PLANNING REPORT
Architectural Review Board
Wednesday, August 28, 2024

38/50 W Bridge St
24-066MPR

Address	38 and 50 W Bridge St, Dublin, Ohio 43017
Proposal	Proposal for a building addition, dumpster enclosure, and site improvements for two properties in the Historic District.
Request	Review and approval of a Minor Project Review (MPR) with a Waiver under the provisions of Zoning Code Section §153.176 and the <i>Historic Design Guidelines</i> .
Zoning	HD-HC: Historic Core District
Planning Recommendation	<u>Approval of the Minor Project Review with a Waiver and conditions.</u>
Next Steps	Upon approval of the MPR by the Architectural Review Board (ARB), the applicant may work with staff to satisfy conditions of approval and file for Building Permits through Building Standards.
Applicant	Timothy Bass, Bass Studio Architects Elie Younes, Bass Studio Architects
Case Manager	Taylor Mullinax, AICP, Planner I (614) 410-4632 tmullinax@dublin.oh.us

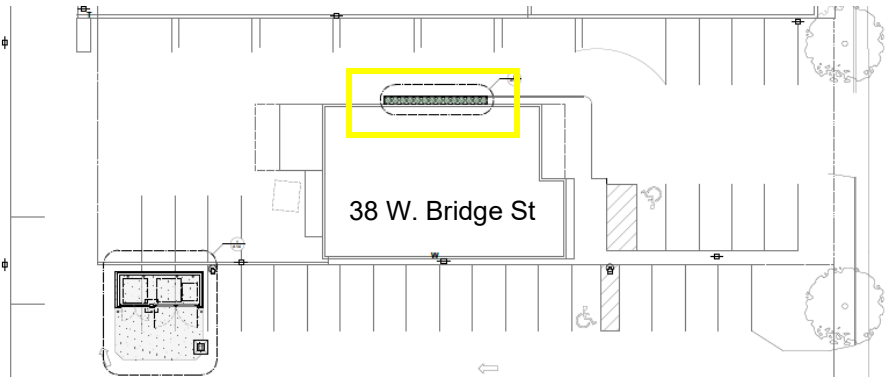
The existing outdoor storage and waste containers at 38 and 50 W. Bridge Street do not meet screening requirements. Currently, there is a dumpster enclosure behind 50 W. Bridge Street that occupies two parking spaces.

To address this, the applicant proposes a new, combined dumpster enclosure for both restaurants, located between the buildings. The new 8-foot-tall enclosure, located at the northeast corner of the building, will also occupy two parking spaces. It will be constructed of CMU with a Red Brick Veneer and a stone cap to match the Fox in the Snow building, and self-closing wooden gates painted Black Magic.

All Code requirements and Guidelines Section 6.8A for outdoor waste enclosures and screening are met. This enclosure fulfills a condition from the 2022 MPR for Fox in the Snow which is a long-term outstanding issue. For that reason, a recommended condition of approval states the combined dumpster enclosure shall be fully constructed, and all additional outdoor waste, storage containers, and vehicles shall be removed from both properties within 60 days of ARB approval.

- 1) A landscape plan for the foundation plantings at 50 W. Bridge Street shall be submitted detailing species, quantities, size at installation, and bed lines, subject to staff review and approval at building permitting.
- 2) The plants at 38 W. Bridge Street are revised and submitted for staff review and approval and planted within 60 days of ARB approval.
- 3) Within 60 days of ARB approval, the combined dumpster enclosure shall be fully constructed, and all additional outdoor waste and storage containers/vehicles shall be removed from both properties.
